P23-05 Foundry Street Self-Storage Units

Property Owner: Foundry Street Holdings LLC
Applicant: Kevin McNulty
Location: West side of Foundry Street with Parcel Number 028-19A-16-044
Zoning: I-1 (Industrial)
Request: Site Plan approval for self-storage warehousing

**PRELIMINARY SITE PLANS
FOR
FOUNDRY STREET
STORAGE BUILDINGS**

LANDSCAPE PLAN
SCALE 1" = 30'

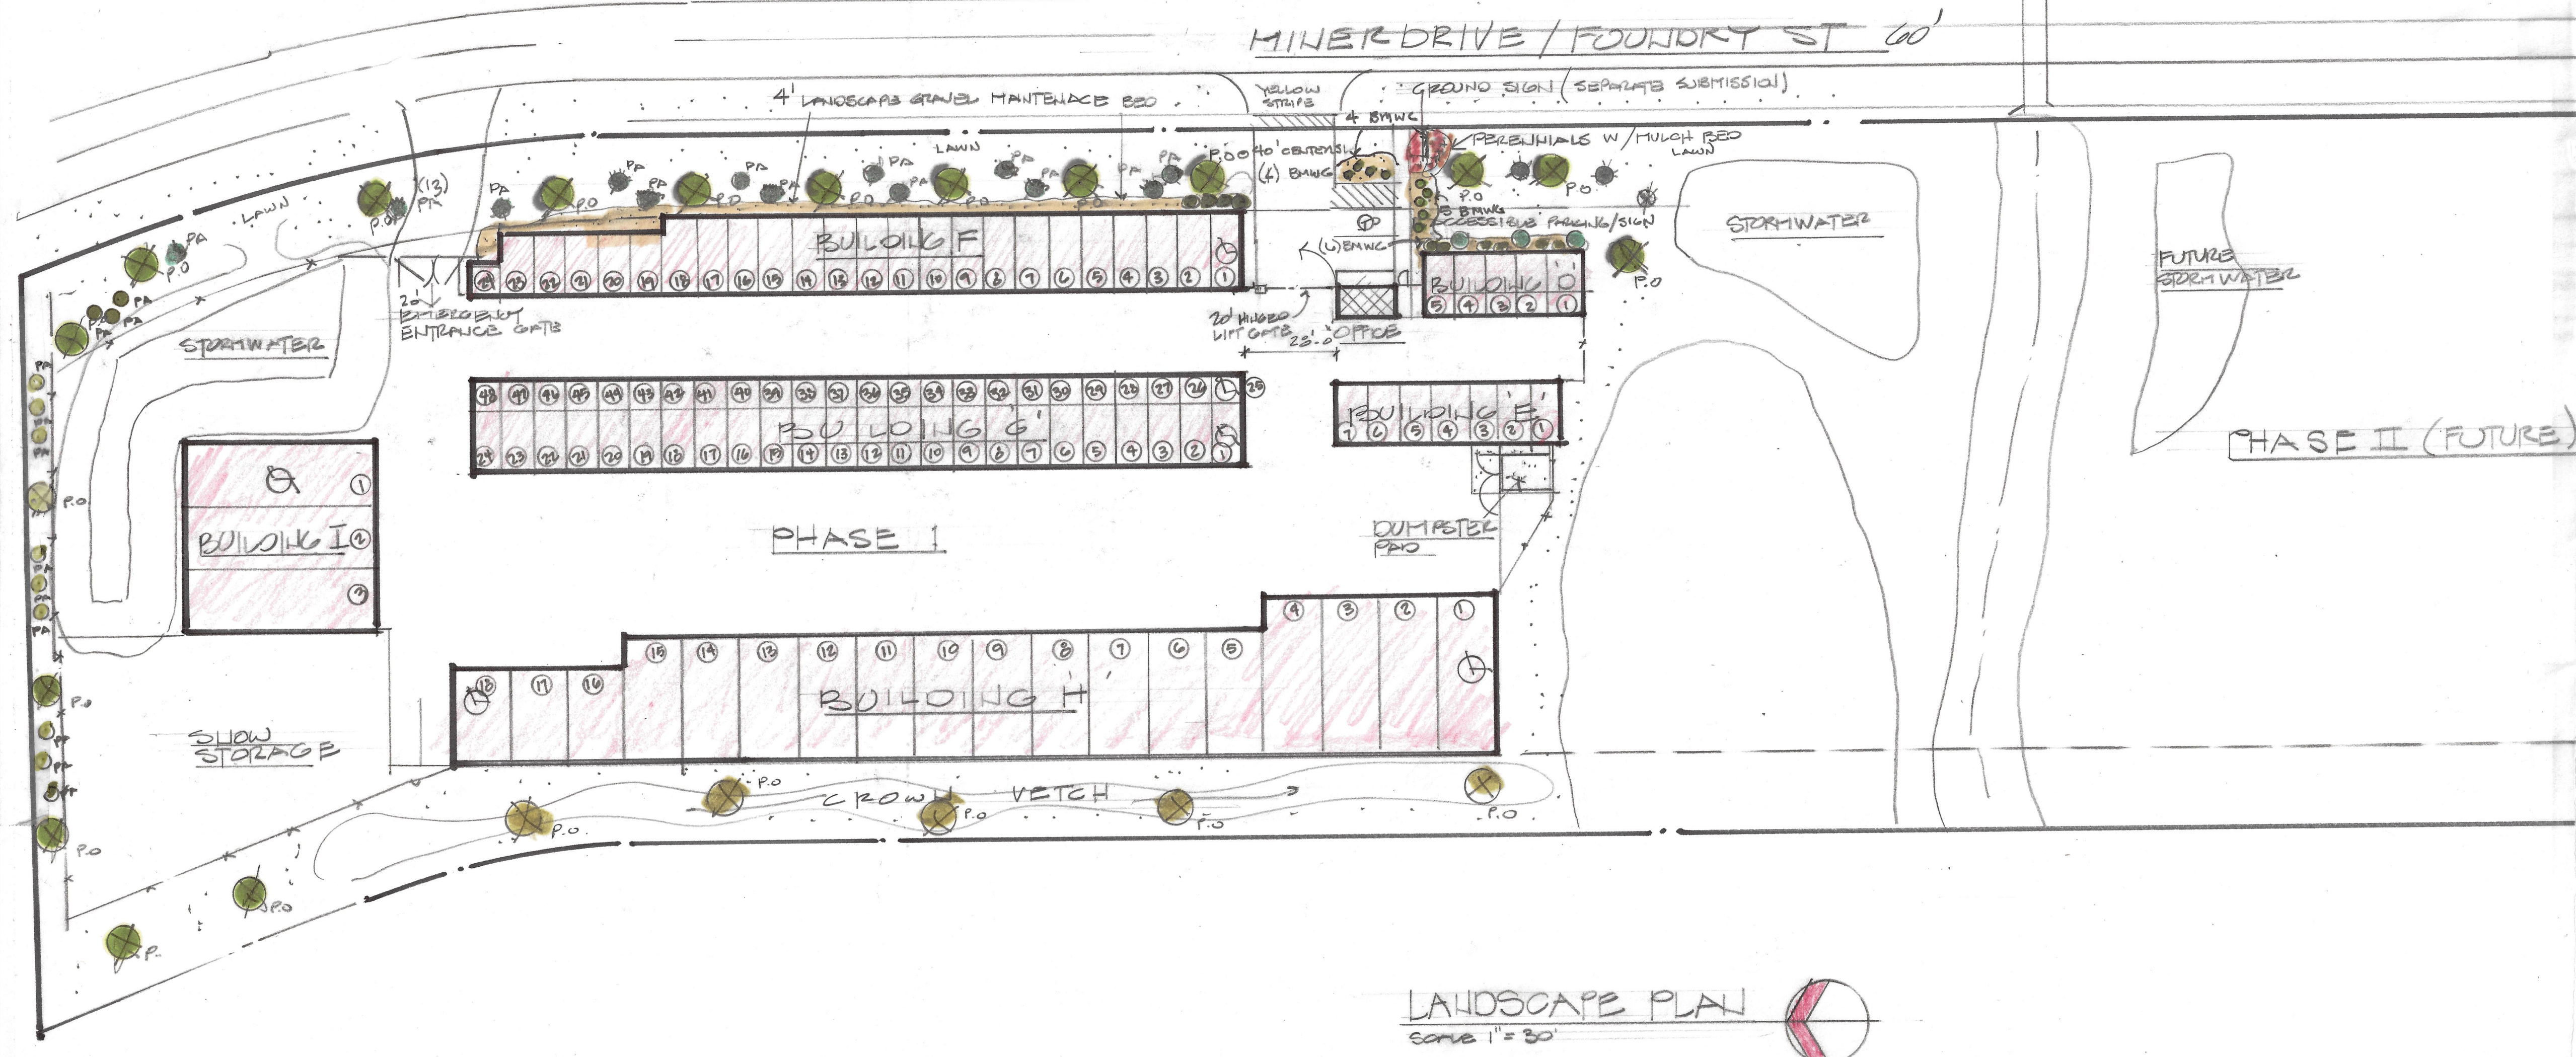
Buffering and Screening – The industrial property abuts a residential zoning district to the north and partially to the east, across Foundry Street. Per Section 1149.05(c), screening must be provided between the site and residential areas. The landscape plan incorporates a landscape buffer along the north and east sides of the site.

Parking Lot Landscaping – Landscape features or other visual barriers are required between parking and the right-of-way per Section 1145.09(b). The landscape plan shows ground signs with landscaping between parking and the right-of-way, which provides a visual barrier.

TYPICAL FENCE DETAIL
SCALE 1/2" = 1'-0"

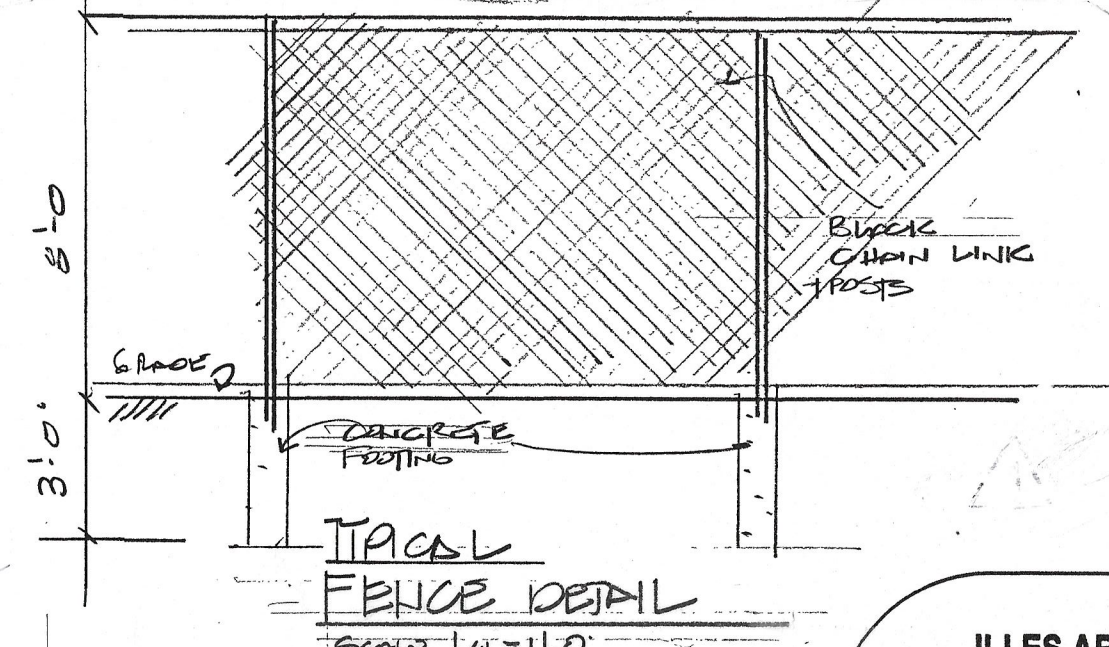
Fencing – Buildings, drives, and stormwater basins are enclosed by an 8 ft. tall black chain link fence. Portions of the fence are located in the front yard, which is the area between buildings and the right-of-way. Per Section 1155.01(c)(1), fencing in the front yard is limited to 6 ft. in height. The applicant has filed a variance application to the Board of Zoning Appeals regarding fencing height in the front yard.

Staff recommends **approval** of application P23-05 Site Plan as submitted, with the condition that the project shall comply with Planning and Zoning Code Section 1141.05 regarding the front yard building setback and Section 1155.01(c)(1) regarding fence height in the front yard, or a variance shall be approved by the Board of Zoning Appeals.

SK 1

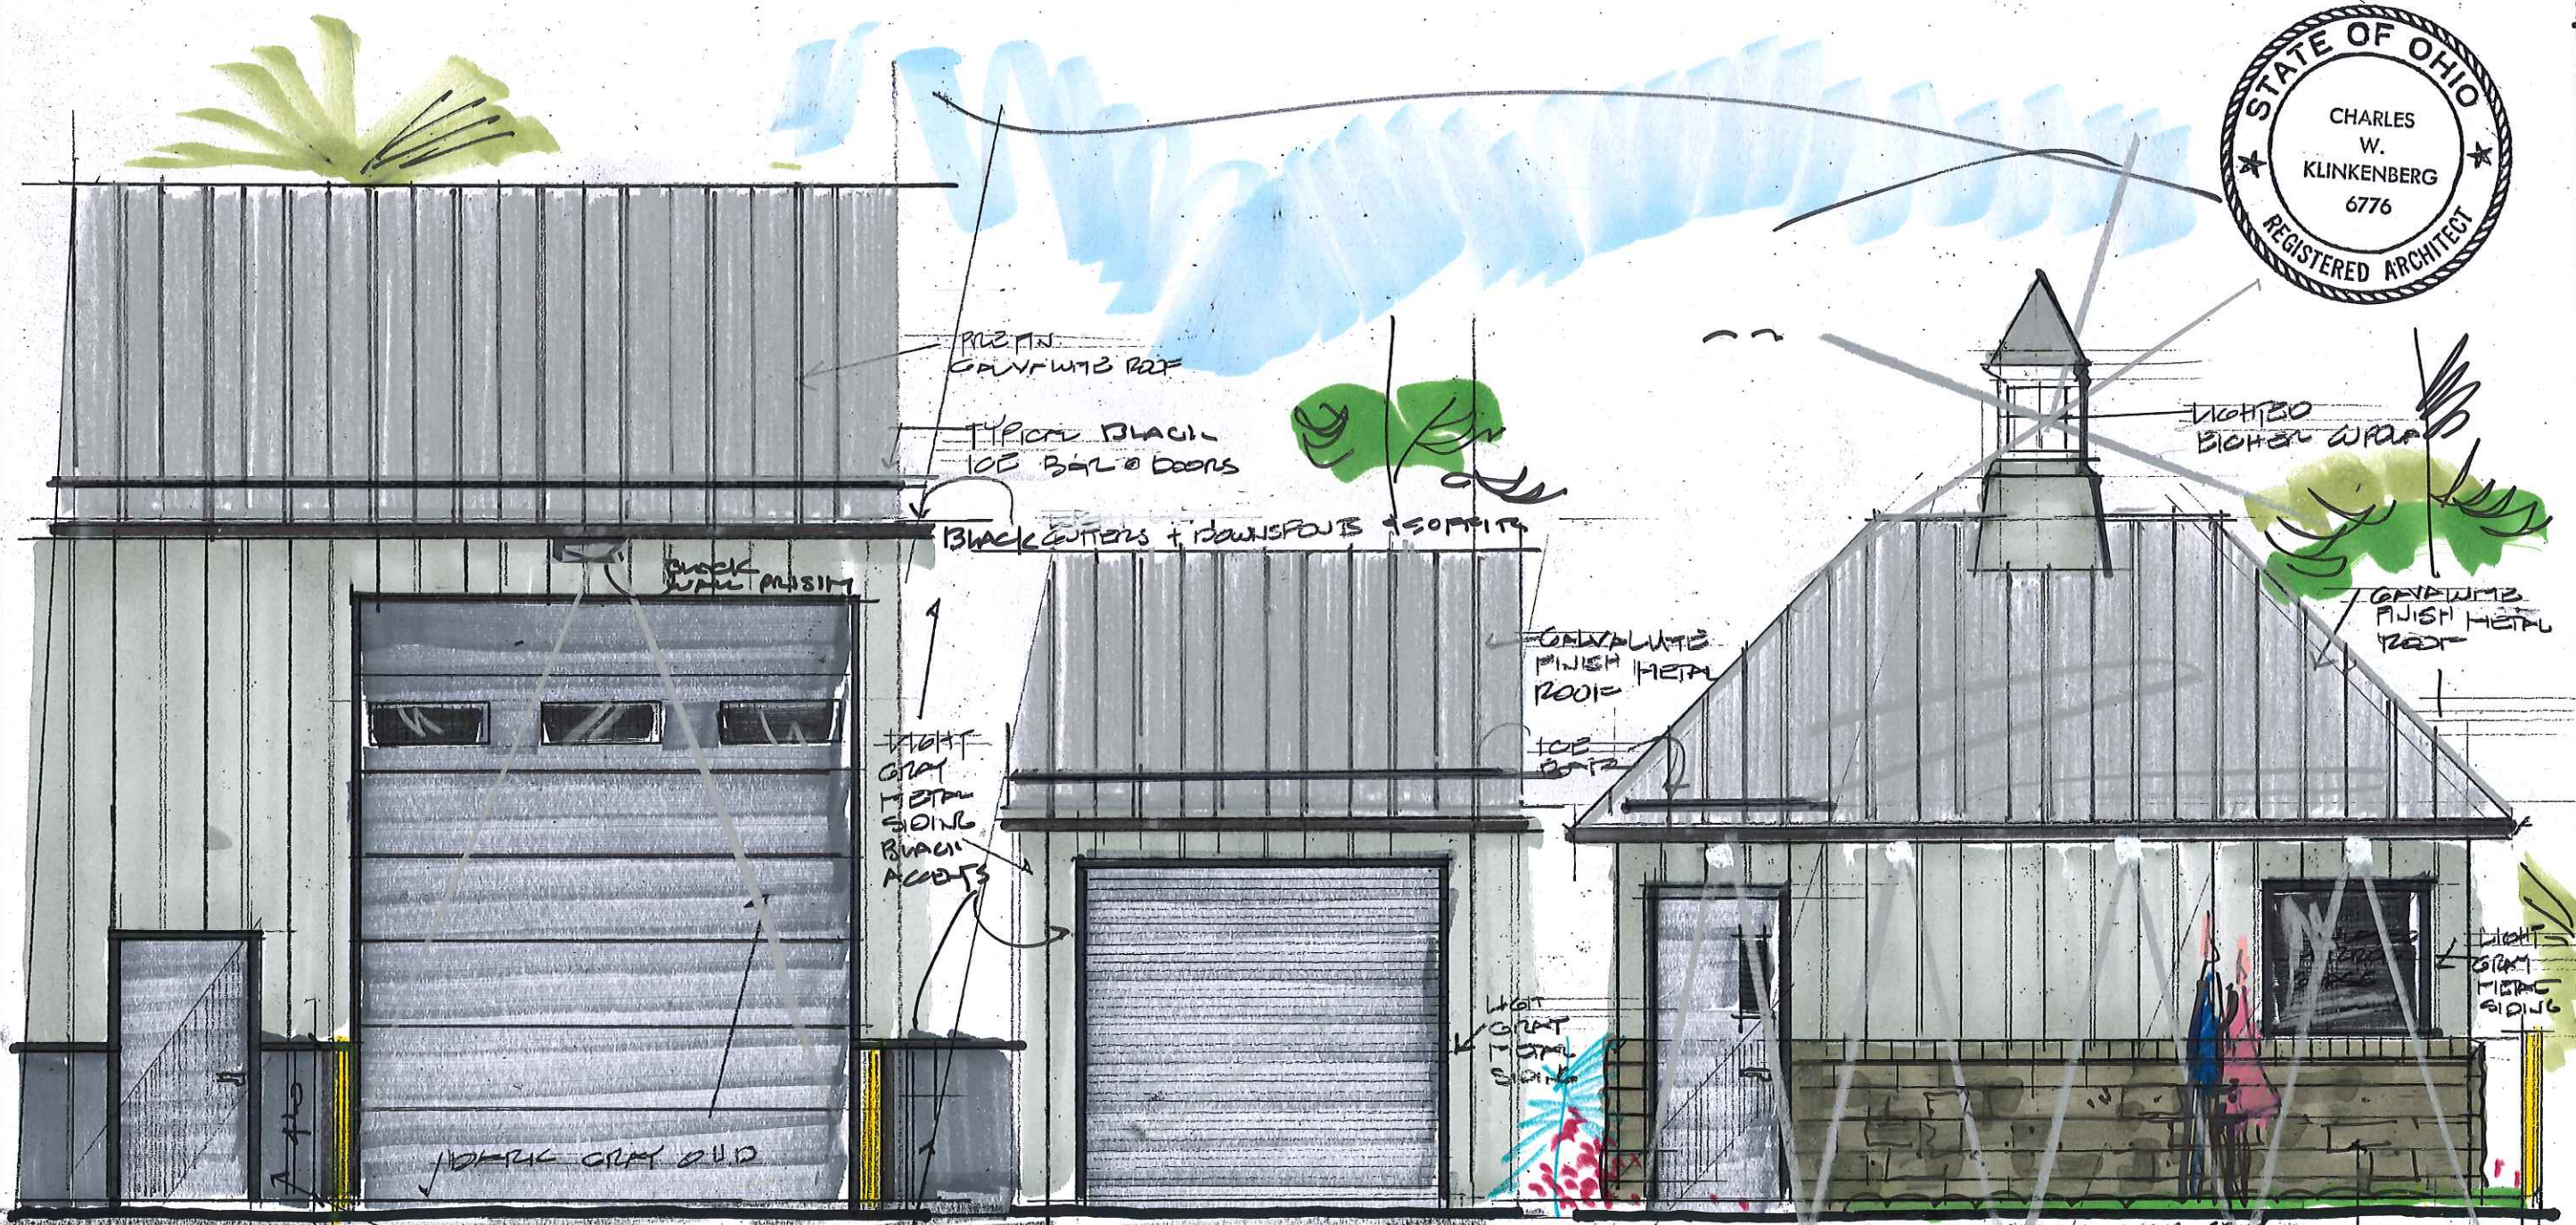
Architectural plans indicate a typical self-storage warehouse design predominantly incorporating vertical metal siding and a pitched roof. In addition, the proposed office includes stone on the lower portion of walls, though it does not appear to incorporate a steeple as shown on sheet SK-1.
